COMMISSION MEMORANDUM

MIAMI BEACH 41 STREET CORRIDOR REVITALIZATION PROJECT

DESIGN REVIEW BOARD PRESENTATION
JULY 2, 2024

SUBJECT: **DRB24-1023 (FKA DRB23-0918)**
41st Street Right-of-Way Improvements

B-K LIGHTING
PALM TREE RING

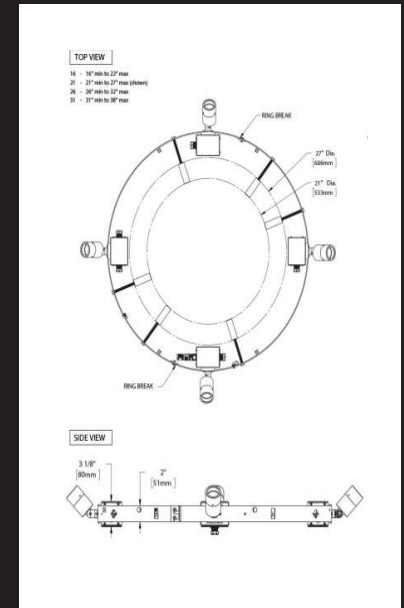
1. Explore utilizing other bright colors (besides Miami Beach pink) for the canopy structures.
2. Miami Beach pink is acceptable for the sidewalk pavement and furniture that emerges from the sidewalk.
3. Miami Beach pink sidewalks should have the same branding features as the grey sidewalks.
4. Utilize the proposed canopy structures to provide shade
5. Utilize the proposed canopy structures to call attention to and embrace the palm trees or shade trees.
6. Option 2 regarding lighting (up and down light for every other Royal Palm tree) is recommended.

The Administration recommends approval of the design, including the replacement of the temporary string lights with permanent up and down lights at every other palm tree, and providing the electrical infrastructure for LPR cameras. The Administration does not recommend the replacement of the existing Acorn light fixtures and poles, for the reasons noted above. Funding for the additional scope will be requested through the Fiscal Year 2026 Capital Budget process.
